Illinois Department of Natural Resources, Office of Water Resources
Public Notice

**Construction of Shore Protection Project, in Lake Michigan,
at 367 and 347 Bluffs Edge Drive, Lake Forest, Illinois 60045**

Re: IDNR/OWR Application-for-Permit **C20240017**
367 Bluffs Edge Drive
Lake Forest, Illinois

GZA GeoEnvironmental, Inc. (GZA) offers the following information and clarification statements in reply to your letter dated August 20, 2024, and our discussion during the site meeting on August 30, 2024. GZA's responses to your information requests are provided below.

Figure 1. Volumetric Calculation for Sand Fill

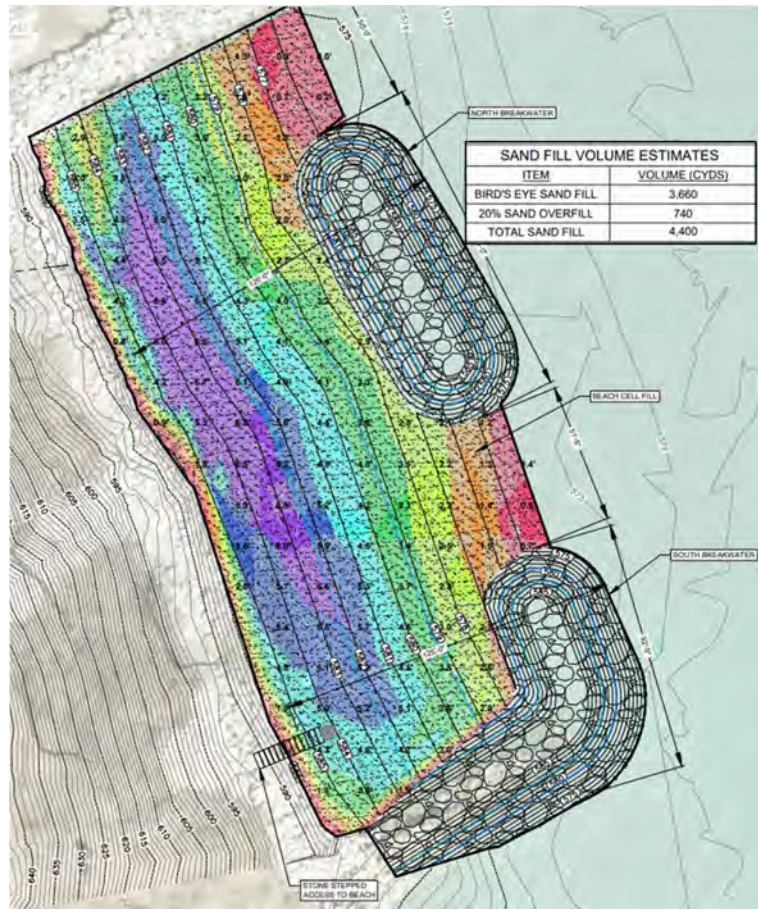
6. *Documentation (i.e., calculations) to support the quantities of proposed sand to be provided to create two beach cells, including the 20% sand overfill.*

The calculations for the proposed sand quantity were performed in Autodesk Civil3D, using a Digital Elevation Model (DEM) created for the existing conditions (surface using the April 19, 2024 bathymetric survey points) and a DEM created for the proposed sand grades. A volumetric difference between these two surfaces provided the sand quantity, with an additional 20% sand over fill provided; see **Figure 1** below.
